## Product Change Notification

1. ECR #: 204137  
Notification #: 579

- UMPT - UMPT ASSEMBLY

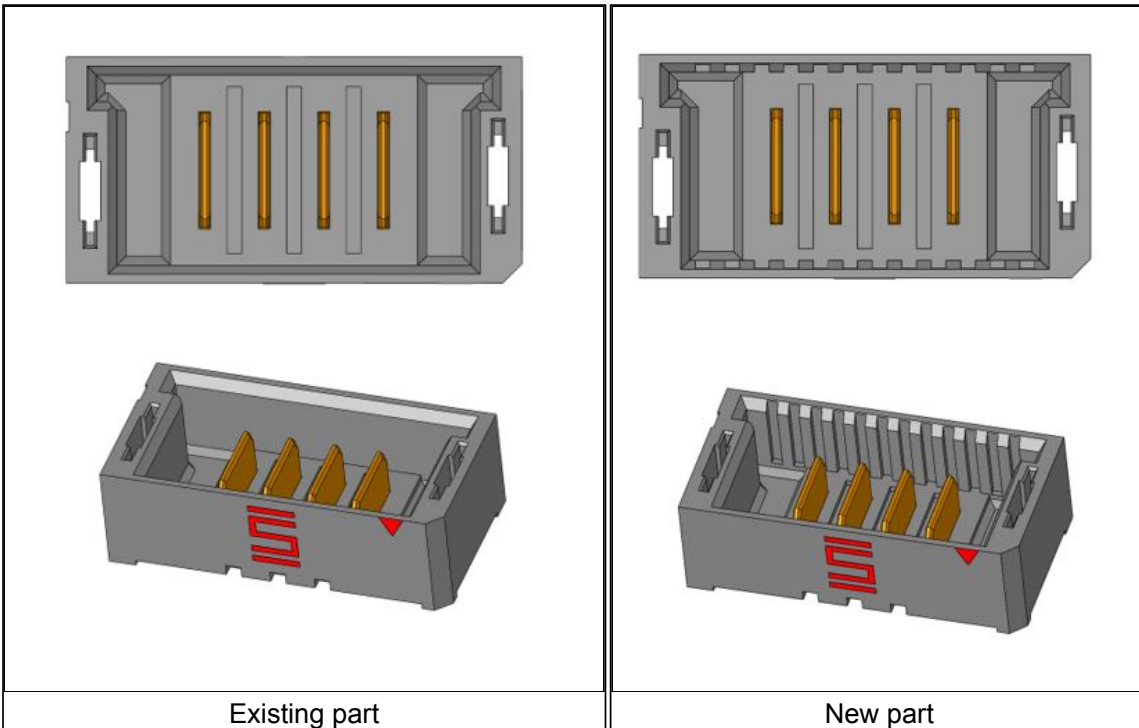
Adding voids to inside wall of plastic shroud.

Change made to improve side wall warpage.

- Form - this is a rolling change and there is some opportunity for mixed inventory on a limited basis.
